Technical Service Bulletin: tsb100214

New Engine Speed Sensor and Jumper Harness

Adaptor Jumper Harness (Part Number 3408526)

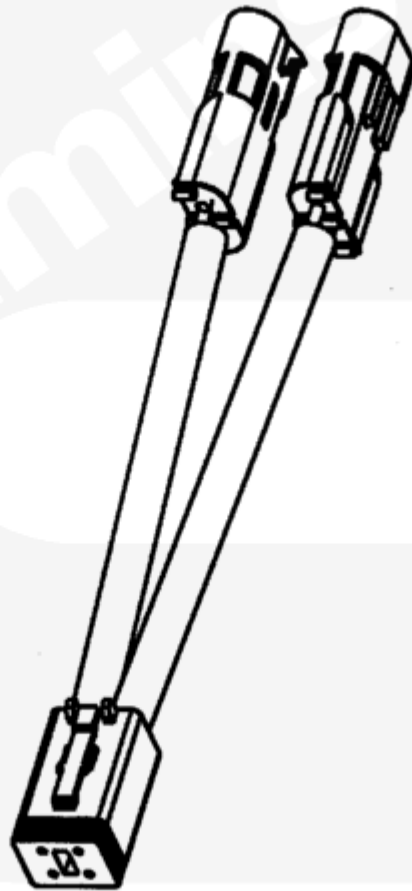
The old sensor has two sets of two exposed lead wires coming from the sensor and terminating into individual 2-pin connectors. The improved design encloses all four leads with convolute and terminates them into a single 4-pin connector.

The old sensor part number has been obsoleted. A jumper harness is required when replacing an older sensor with the new design. The jumper harness adapts the single 4-pin connector on the new sensor to the two individual 2-pin connectors on the harness. The jumper harness is **not** required when replacing sensors on engines built with the new foam-filled metallic harness, which is often referred to as the Phase 2 harness.
